PITCH VARIATION

POLAND PROPOSAL

GROUPE RENAULT

Results for « Clio IV » 5 seats

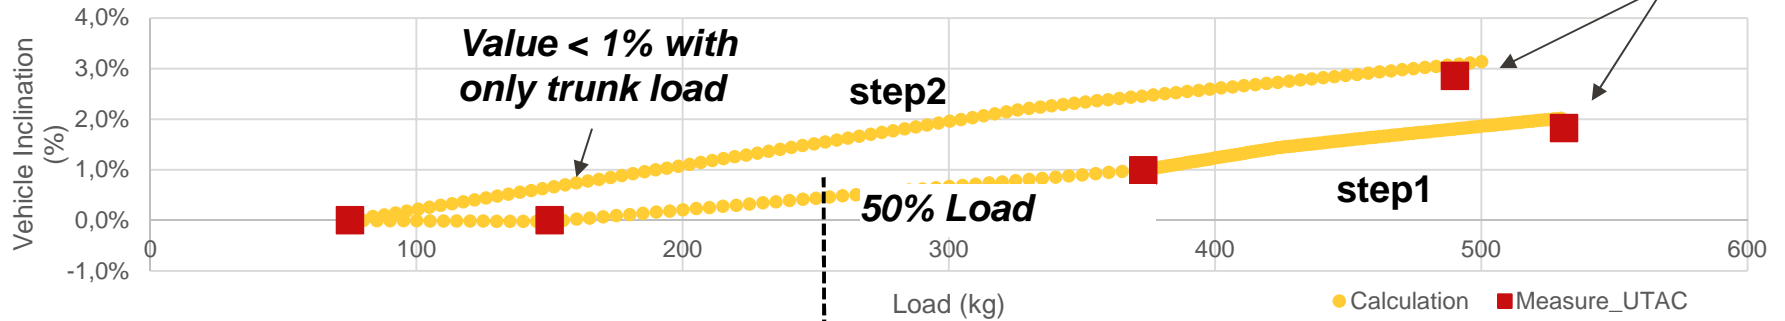
Véhicule	Calculations of variation	Measures of variation (UTAC)
I_0	0%	0% (-1% réel)
I_{min}	-0,02%	0%
I_{max}	3,13%	2,85%
ΔI	3,16%	2,85%

Results for « Grand Scénic » 5 seats

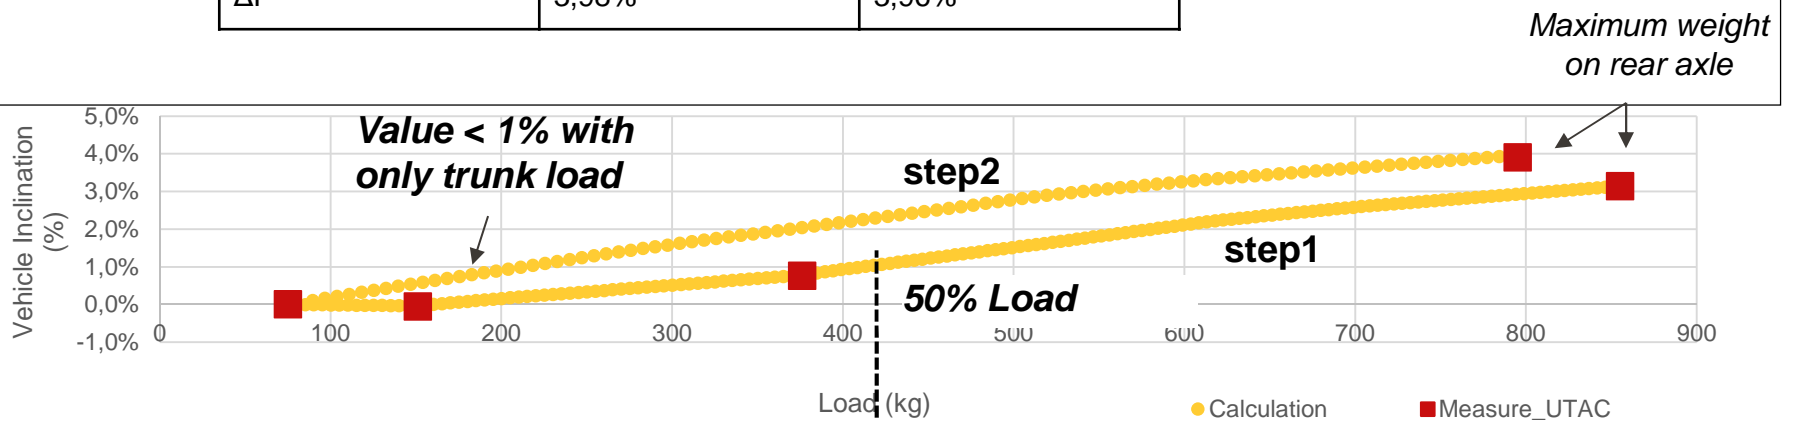
Véhicule	Calculations of variation	Measures of variation (UTAC)
I_0	0%	0% (-1% réel)
I_{min}	-0,04%	-0,06%
I_{max}	3,95%	3,9%
ΔI	3,98%	3,96%

Do you see this type of load every day by night ?

ANNEX - Pitch vs. Loading

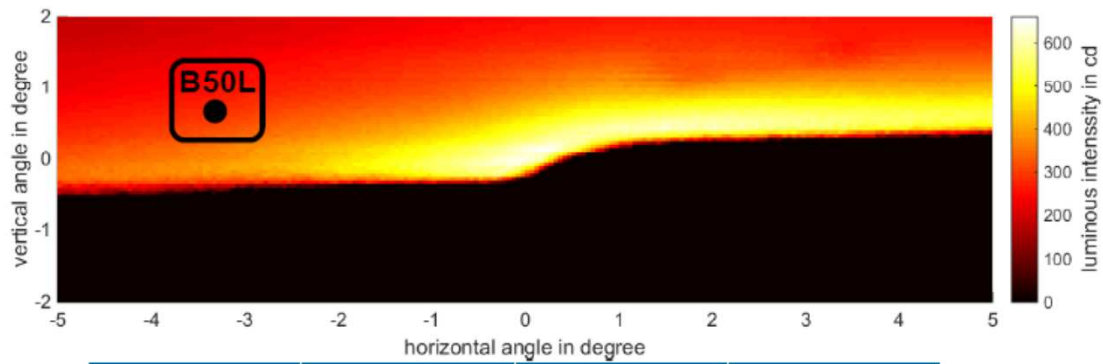
- Range of pitch: 0 cm – 18 cm:
 - Reason for relatively low influence on rating mean at 50%
- 6 cars are above horizontal line
→ High Glare Potential

- 4 cars: Pitch from 21 cm – 23 cm
→ High Glare Potential

- Assumption: The relative small difference between the two clusters 0% and 50% is caused by the high deviation of pitch at 50% loading.
- Conclusion: Clusters had to be built based on pitch condition and independent of loading condition
